UNITED STATES PATENT AND TRADEMARK OFFICE

Office Action Summary

10/083,079

SCHUTZ, DOMINIK

ATTACHMENT 1

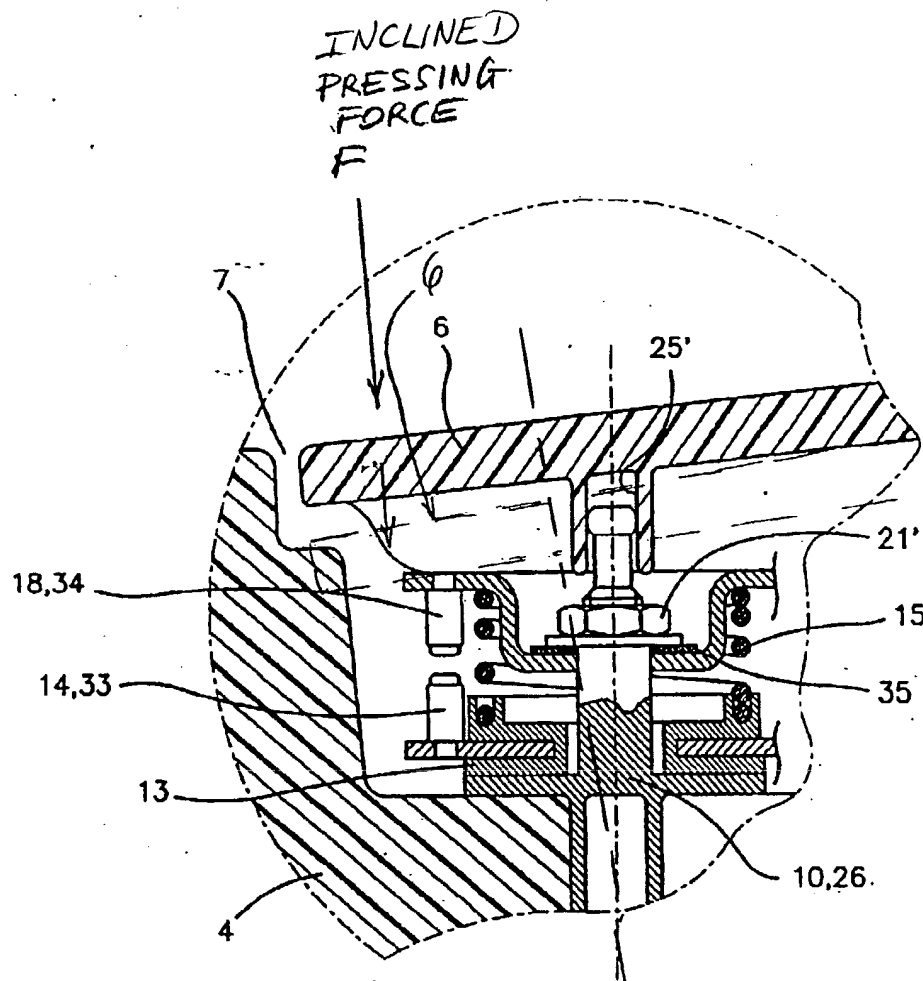
Regarding claim 3, said gas bag module 5 has a cup-shaped receiving housing 17 which is open toward said covering cap 6 and adapted to receive a gas bag 16, an edge of said receiving housing 17 having extensions 17 (Fig. 2, see Attachment 1) projecting laterally outwards and toward said edge 24 of said covering cap 6, said guides 10 or 10, 26 being provided on said extensions 17.

ATTACHMENT 2

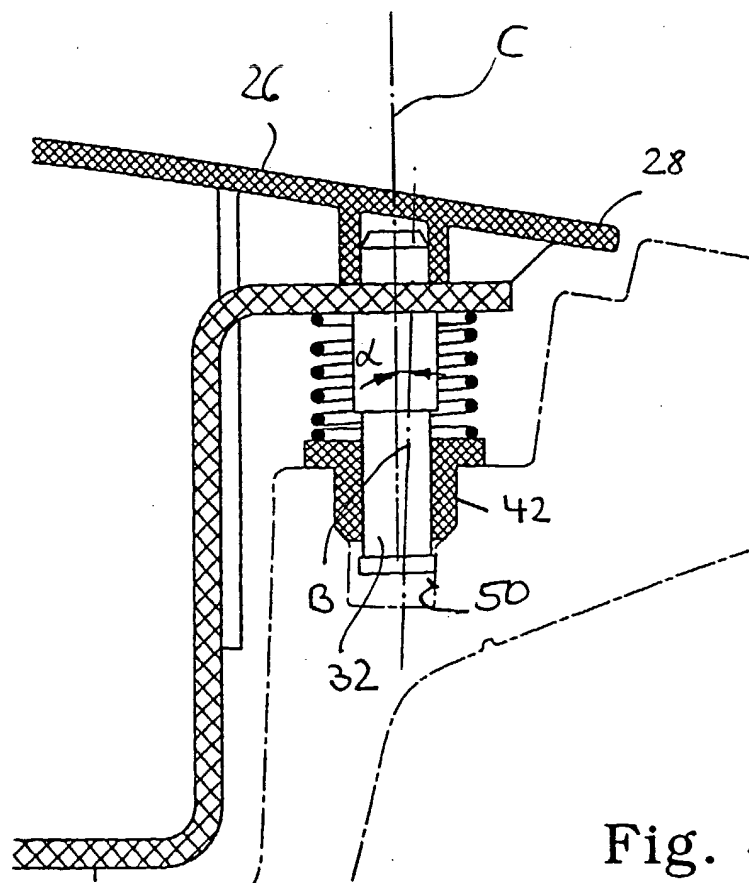
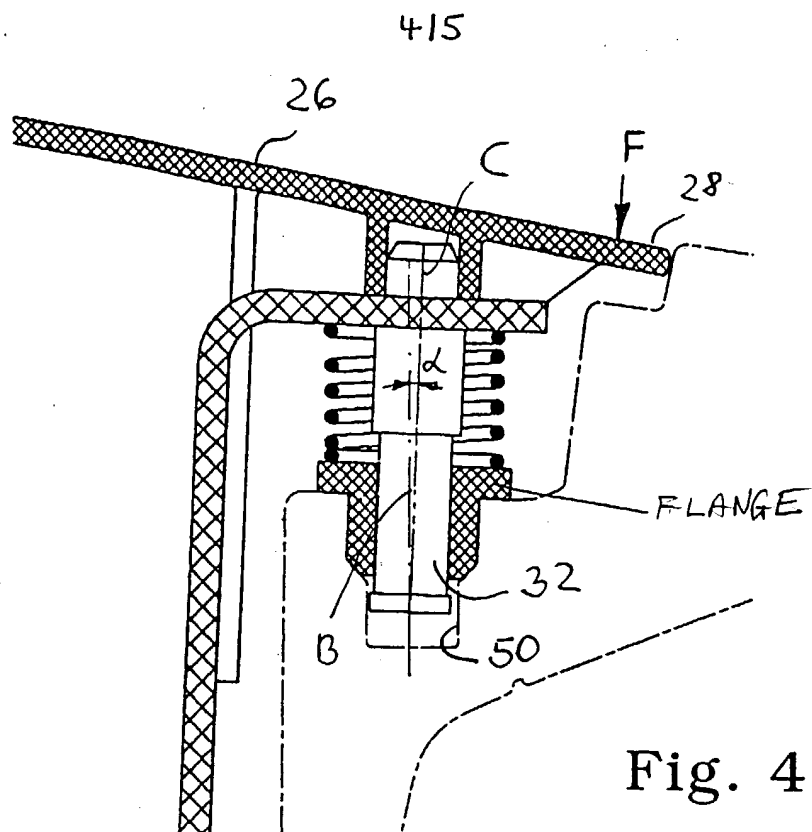
On the other hand, Bohn's flange 11 and washer 13 are similar to the flange of Applicant's bearing bushing 42 in Fig. 5 (see Attachment 2), *a fortiori*, they are expected to behave similarly. In other words, when one applies a sufficient inclined force at the region of the

edge of Bohn's casing 6, Bohn's flange 11 and washer 13 do not prevent the tilting of the studs 10 in the same manner shown in Applicant's Figs. 4a and 4b. *In re Merck & Co., Inc.*, 231 USPQ 375 (CAFC 1986) and *In re King*, 231 USPQ 136 (CAFC 1986).

6052TRW1

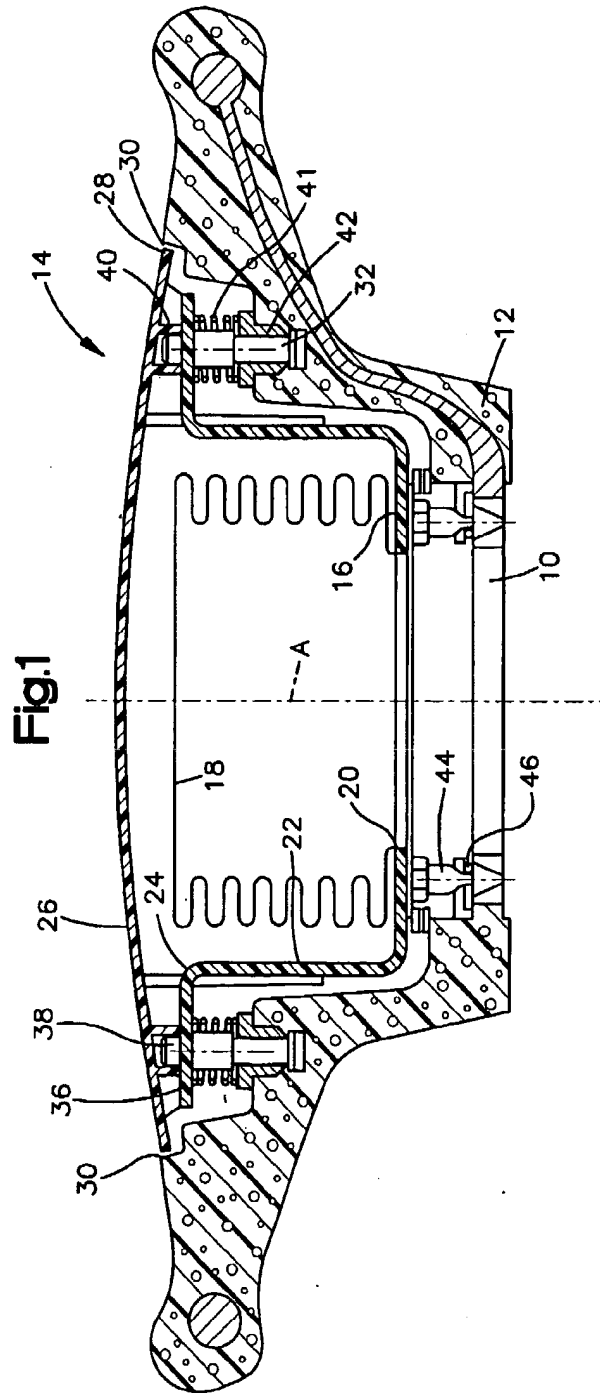
2. The replacement drawings were received on March 8, 2004. These drawings are unacceptable by the Examiner because Applicant does not: (a) identify the replacement drawing sheet in the top margin as "Replacement Sheet"; and (b) include all of the figures. For example, Fig. 3 is missing. See information on how to effect drawing changes below.

4. The drawings are objected to because Fig. 1 should have referential numerals 62 and 64 to designate the electrical contact in claim 1. Corrected drawing sheet set forth in the information on how to effect drawing changes above are required in reply to the Office action to avoid abandonment of the application.

The original Fig. 1 shows that the element 12 is made of sand or the like in accordance with the drawing symbols for draftspersons in MPEP 608.02. Similarly, claim 5 calls for the plastic housing 16, however, the original Figs. 1-5 do not show the drawing symbol for plastic in MPEP 608.02.

6. The original disclosure is objected to because of the following informalities: the specification and the claims are inconsistent with the original drawings. For example, claim 1 claims the foam casing 12, however, the original Fig. 1 shows that the element 12 is made of sand or the like in accordance with the drawing symbols for draftspersons in MPEP 608.02.
